**PLANNED UNIT DEVELOPMENT  
STAFF REPORT****Date: August 20, 2015****DEVELOPMENT NAME**

Joseph N. Asarisi, P.E.

Planned Unit Development Approval to amend a previously approved Planned Unit Development to allow shared access and parking between multiple building sites.

# PROP SITE PLAN

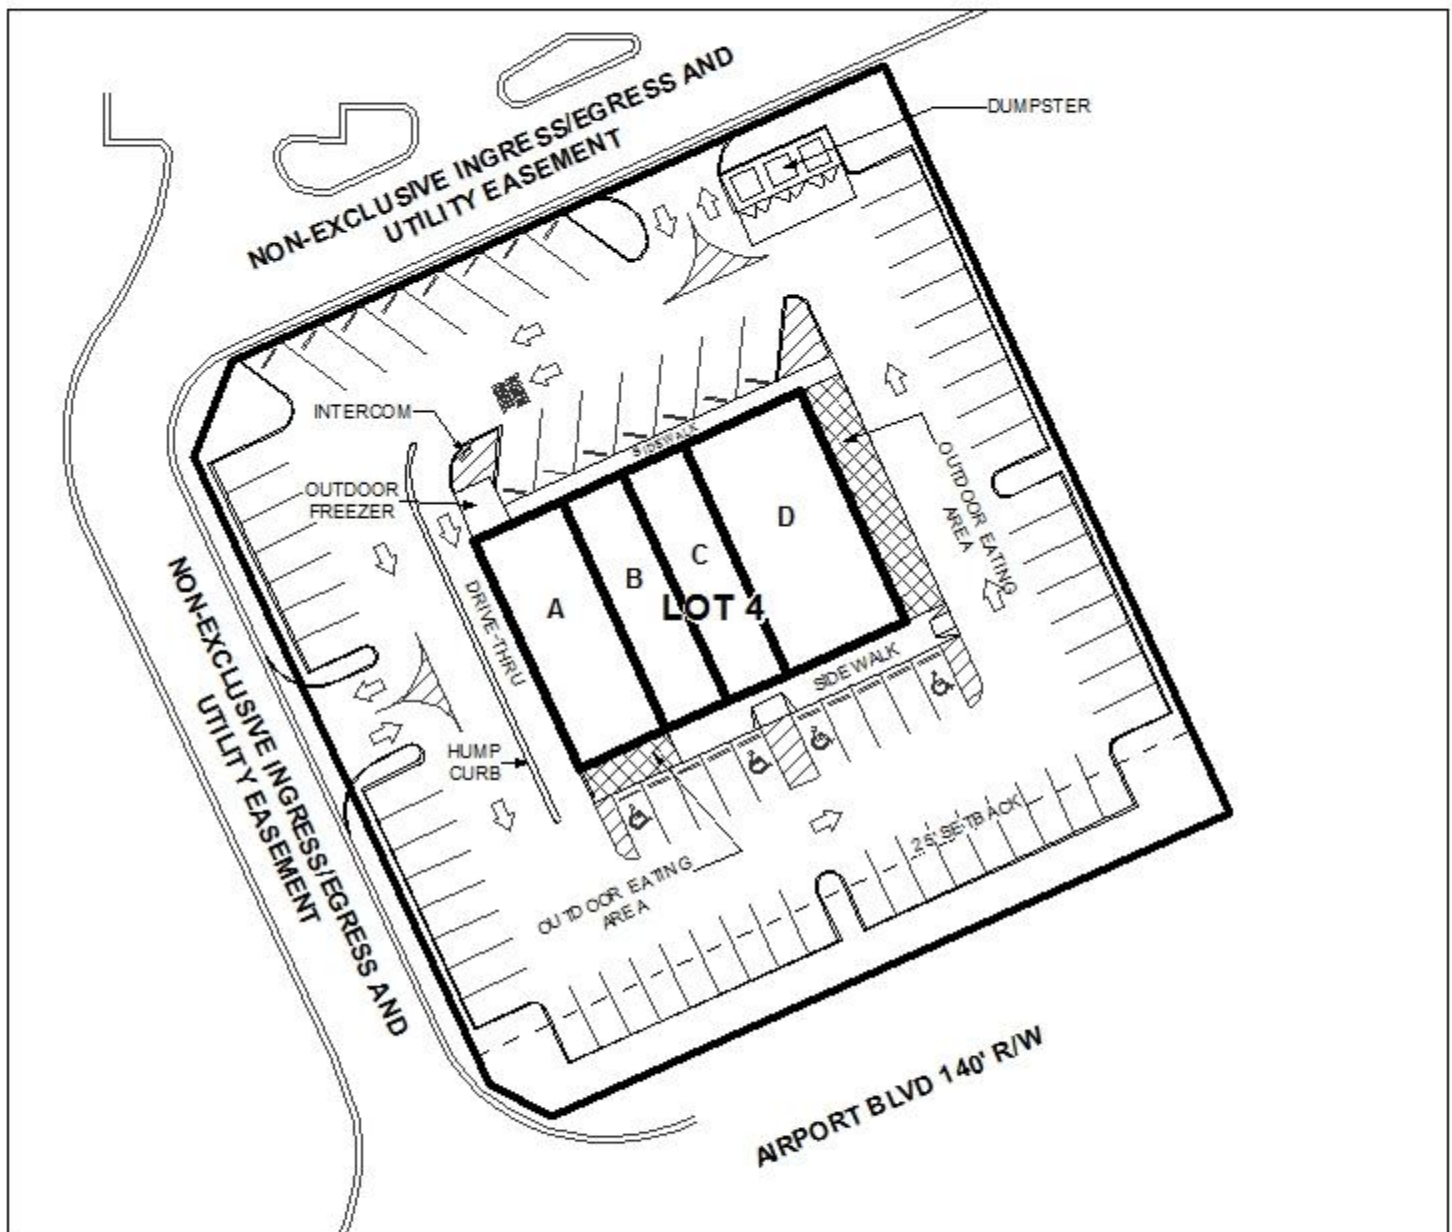
The proposed drive-thru on west side of building is not desirable as currently shown, as traffic in the middle has vehicles opposing it on both sides. An option is to make the circulation counterclockwise around the building, with 20' aisle and angled parking. Another alternative could be a striped separation, since the drive-thru lane can be as narrow as 9'. This option is/ could be feasible, depending upon the order station location, and anticipated queue length. If the queue space extends beyond the side of the building to the rear, the drive aisle is not wide enough to accommodate two circulation lanes and a drive-thru lane.

*The driving aisles around the site have been designated for one-way traffic, and sufficient width has been provided for the driving aisle and drive-thru queue lane. With ninety-degree parking*

*and one-way designation, the arrows proposed in the travel aisle will need to be thermoplastic material (not paint), to extend the life of the markings.*

The proposed development of Lot 4 will consist of a 6,745± sf building, to be comprised of 1 suite planned for a retail use and 3 suites proposed as restaurant uses, with a total 2,087± sf of sidewalk / outdoor dining area abutting the southern and eastern sides of the building. As proposed, the anticipated mix of uses will require 81 parking spaces. 83 new parking spaces are proposed, which exceeds the minimum requirements of the Zoning Ordinance for required onsite parking spaces; however, the site plan should be revised to reflect accurate parking calculations.

It should be pointed out that on-site traffic circulation is a concern due to a proposed drive-thru adjacent to Suite A, along the western side of the building. As no information was provided regarding the location of the order menu or service window, Staff is not able to determine if a sufficient number of queuing spaces will be provided. As such, the site layout should be revised to coincide with Traffic Engineering comments and illustrate full compliance with Section 64-4.F. of the Zoning Ordinance, regarding design standards for drive-thru businesses.

In regards to trees and landscaping, compliant landscaping data is depicted on the site plan; however, the provision of frontage trees on the site plan is required along Airport Boulevard. As such, a compliant number of frontage trees should be illustrated on the revised site plan.

*It should be pointed out that landscape data is illustrated on the site plan; however, the depiction of frontage trees along Airport Boulevard should be illustrated on the revised site plan.*

- 1) Depiction of frontage trees along Airport Boulevard on the revised site plan;*
- 2) Retention of landscaping illustrations and notes on the revised site plan;*

- 6) Compliance with Traffic Engineering comments (The driving aisles around the site have been designated for one-way traffic, and sufficient width has been provided for the driving aisle and drive-thru queue lane. With ninety-degree parking and one-way designation, the arrows proposed in the travel aisle will need to be thermoplastic material (not paint), to extend the life of the markings.);*
